Number	Description
1	Revised Bid Items; Revised Plan Sheet Nos.RVP-1, 4, & 7; Amendment EBSx Download Required.

MP-1172-71(002)/ 310038301000

Scrub Seal & Overlay approximately 12 miles of MS 172 from the junction of US 72 to the Junction of US 72, known as State Project No. MP-1172-71(002) / 310038301 in Tishomingo County.

ADDENDUM

SHEET ID
TS-2
 SHEET NO.
4

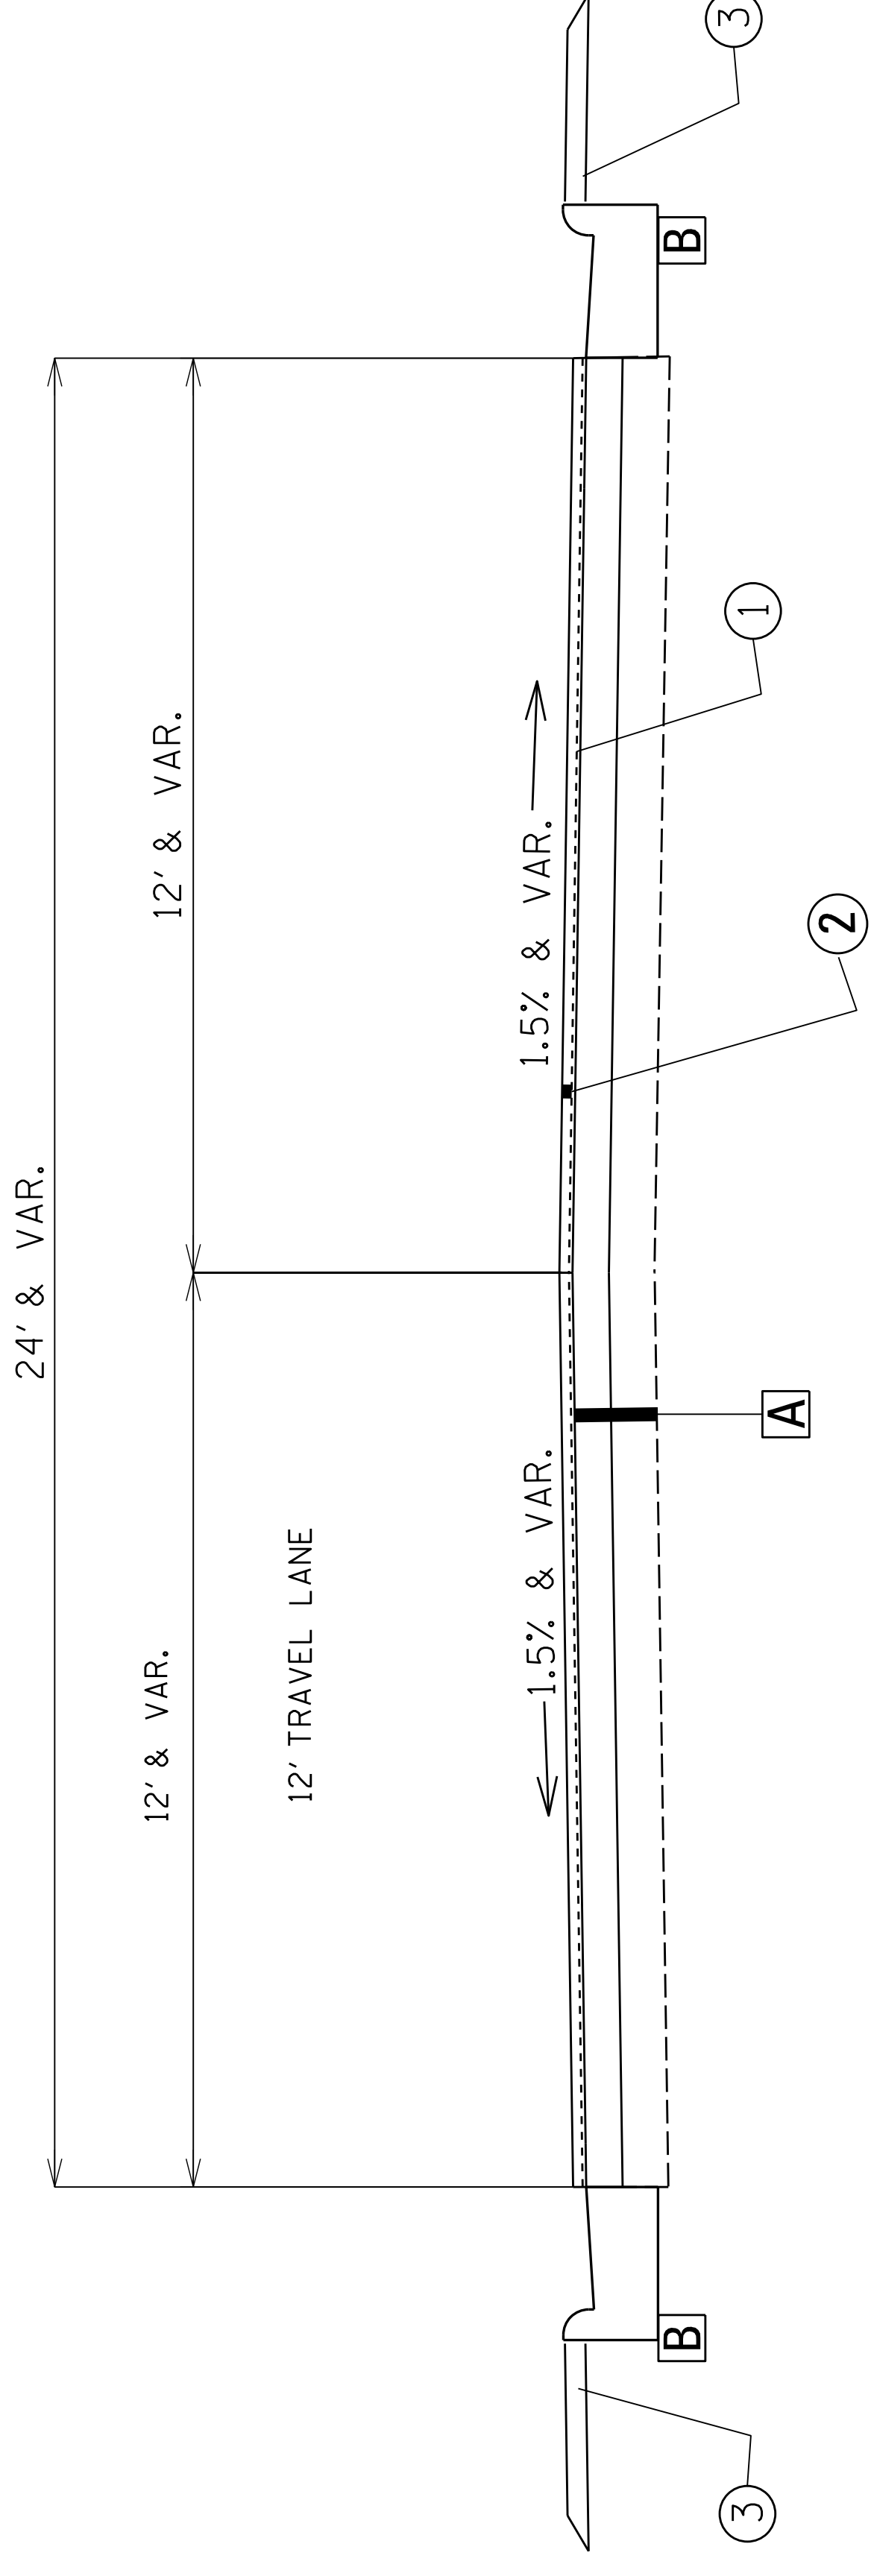
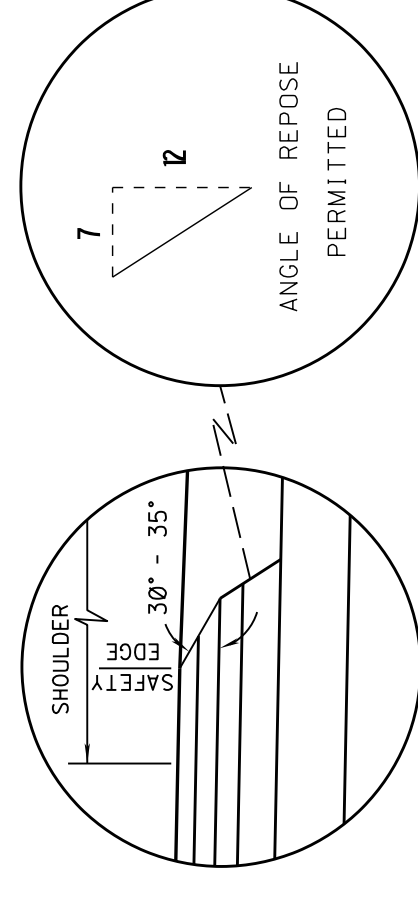
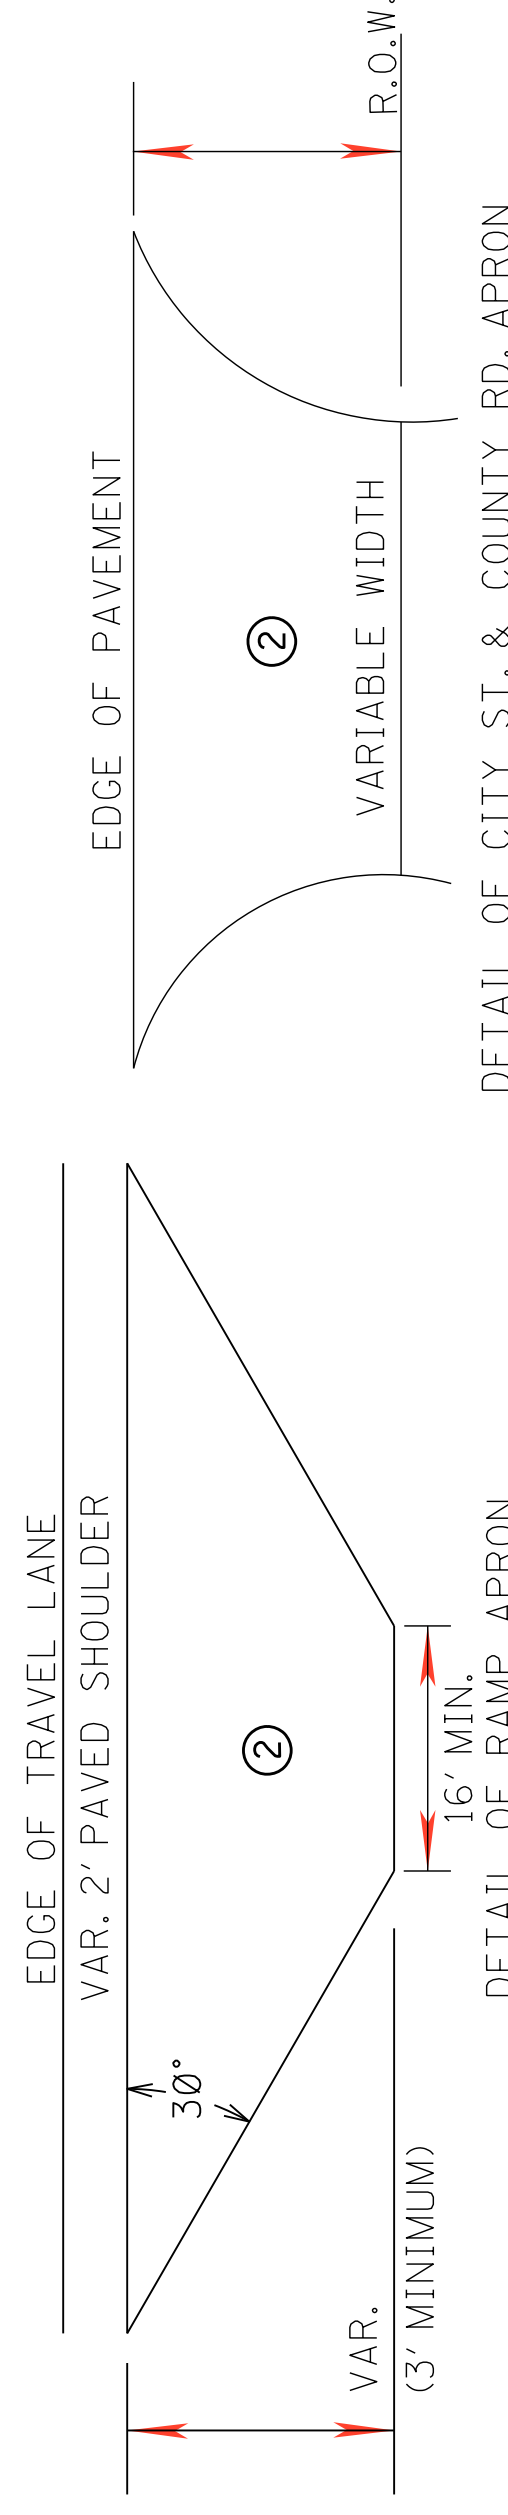
REVISIONS	DATE	BY
①	3/18/26	RCE
②	4/20/26	RCE
③	5/18/26	RCE

① STA. 409+70 - 441+70

- ① 1.5" AND VARIABLE FINE MILLING OF BITUMINOUS PAVEMENT, ALL DEPTHS, PAY ITEM NO. 406-D001 REQUIRED.
- ② 1.5" 9.5mm, MT, ASPHALT PAVEMENT, PAY ITEM 907-403-A014 REQUIRED ON SURFACE COURSE.
- ③ 1.5" AND VARIABLE GRANULAR MATERIAL (CLASS 3, GROUP C) (LYM) PAY ITEM NO. 304-A002 REQUIRED ON SHOULDERS.
